Substantive response of the Local Highway Authority to a planning consultation received under The Development Management Order.

Planning Application Number: 24/00083/HYB

Application Address: Land At Burbage Fields Farm Bullfurlong Lane Burbage Leicestershire

Description of Application: Re-consultation. Hybrid planning application for 422 dwellings, public open space, associated infrastructure and the demolition of 65 and 65a Coventry Road, and Burbage Fields Farm and outline planning application for a residential care home and up to 11no. self-build plots (all matters reserved except for access)

Figure 1: Extract of Definitive Map of Public Rights of Way within proposed development

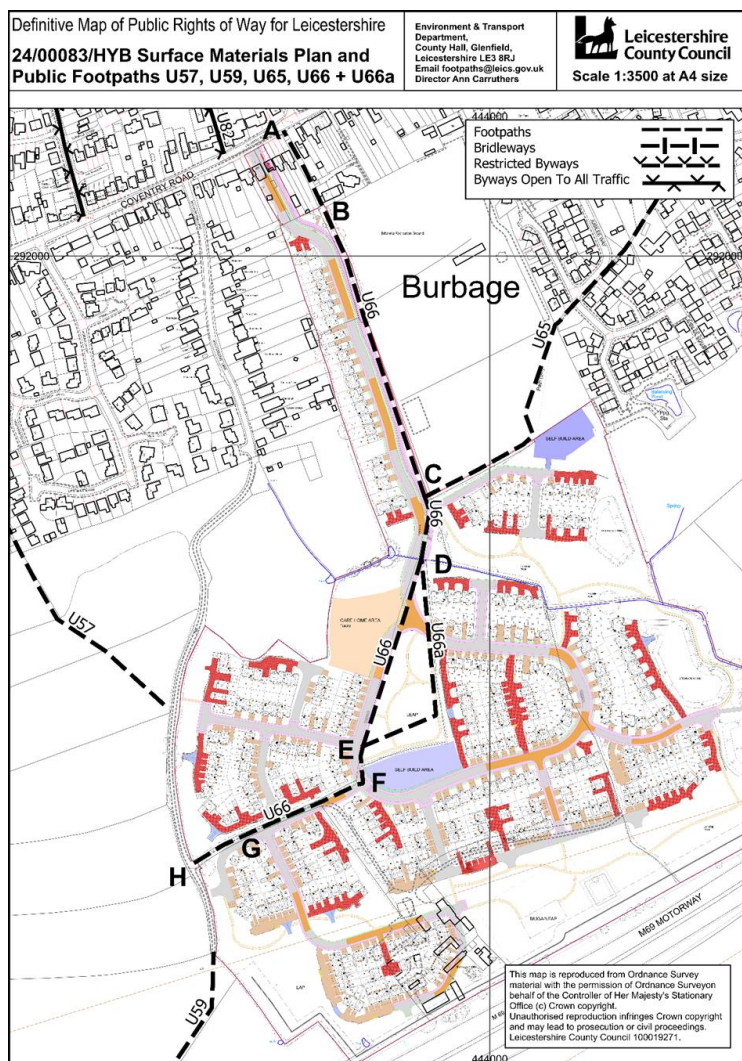
Included below is the latest submitted Surface Materials Plan (drawing no.1693-08-02-140 - Rev A) overlaid with the footpath routes as recorded on the Definitive Map of public rights of way, the official record. The Definitive Map legally 'fixes' the routes of public footpaths, bridleways etc. Routes on the ground may be different but, in law, the route on the Definitive Map is the alignment that must be used by planning proposals. If not, a legal diversion of the right of way will be needed.

The Surface Materials Plan shows the location and treatment of highways (i.e. carriageways), roadside footpaths, linking paths and paths through landscaped areas. The overlay highlights the following:

- Only Roadside Footway between points C, D, E, and F on the eastern side of the access road or primary street. Footpath U66 here is largely subsumed by the footway shown as to be adopted on the submitted Highway Adoption Plan. This conflicts with government policy in PPG / C1/09 paragraph 7.2 as quoted above in item (7) and LHDG annex para 10 quoted in item (8). It is noteworthy that the submitted amended Illustrative Landscape Masterplan (drawing no. P22-2560_EN_0007_F_0001 Rev F) omits PRoWs generally but includes the 'Burbage Round Walk' shown as being on the western footway of the primary street. The western side of the

- It is unclear which roadside is used between points F and G. The Surface Materials Plan and Highway Adoption Plan only show a footway on the southern edge of this side street. The crossings over the development's primary street and onto the side street at point F are indirect and sub-optimal. This conflicts with PPG / C1/09 para 7.2 and LHDG annex paragraph 10 in item (8). It is again noteworthy that the Illustrative Landscape Masterplan shows the 'Burbage Round Walk' as being along the northern edge of the side street, which is a more appropriate location for Footpath U66. But to allow this a roadside footway must be added on the northern side of this street.

- No provision at all between points G and H for Footpath U66, contrary to NPPF paragraph 105 as noted above in item (5) and the BNP noted above in item (1). Currently, at this point, the route of Footpath U66 follows the access track for Burbage Fields Farm so an equivalent surface should be provided. Appropriate barriers are required at point H to allow pedestrian access but ensure vehicles do not use this as an unofficial site exit onto Bullfurlong Lane.

- No provision at all between points D and E for Footpath U66a; strictly this also is contrary to NPPF paragraph 105. Footpath U66a legal existence was confirmed by a tribunal in the mid-1950s after the Definitive Map was initially compiled in 1951-52. If Footpath U66a is being extinguished rather than diverted there needs to be a clear justification for doing so, and potentially equivalent improvements elsewhere to compensate for the loss of this public asset.

- The situation is unclear between points B and C for Footpath U66. There is no provision on the existing legal alignment but the Surface Materials Plan and Highway Adoption Plan both show, parallel with the development's primary street, a wider footpath which appears to be the segregated cycleway from Coventry Road mentioned in the Design and Access Statement Addendum paragraph 2.1. Is this a combined footpath and cycleway, or separate cycleway and footpath parallel to each other? If the latter, the footpath should be on the eastern side of the cycleway so it coherently links to the other footpaths such as Footpath U65.

- The position is unclear between points A and B as to what happens to the existing route of Footpath U66, where it coincides with the current landholder access route to the fields. That land is outside the site boundary and has no owner recorded by the Land Registry, though it is believed to be used by Burbage Parish Council to access their recreation ground and appears to also be an access to land title LT483575 which is part of the application site.

- Leaving the PRoW and this land in its current state is implicitly contrary to NPPF paragraph 105 may cause other public nuisances. Compared to via the primary street, this section of Footpath U66 can be made into the shortest all-weather surfaced pedestrian route from the application site to the Burbage village centre. That should include resources to allow this section of PRoW to be surfaced to adoptable standard, with a connection to the cycleway and footway around point B.

- Future status unclear for the new route labelled 'Emergency Link and Continues Cycle Link' linking the eastern and western parts of the development. The Surface Materials Plan showing it as being constructed to adoptable standard, but the Highway Adoption Plan shows it as not adopted. To safeguard public access for pedestrians and cyclists this should be dedicated as a public right of way Bridleway.

- Proper access provision at point C where there is a site exit of Footpath U65 which forms part of the Round Burbage Walk route. The Highways Act 1980 Section 146 means stiles and gates on PRowS are the landowners' responsibility. Reflecting the Equality Act 2010, government policy is that PRow barriers should be the 'least restrictive' option possible and be accessible to users with reduced mobility; instead of the current stile, the applicant would be required to provide an accessible gap, or pedestrian gate, or kissing gate.

The LHA would advise the applicant that if the proposals had been acceptable improvements would have been requested in line with the NPPF paragraph 105 expectation of PRow enhancements. In addition to providing resources for an all-weather surface between points A and B, and reflecting the 'significant increase in use' the development will lead to on surrounding footpaths mitigation would have been sought to provide resources for improving footbridges, waymark posts, and stiles, or replacing stiles with pedestrian gates or kissing gate, on Footpath U57 to Coventry Road, on Footpath U59 to the A5 Watling Street, and on Footpath U65 to Britannia Road, and Footpath U81 to Lutterworth Road.
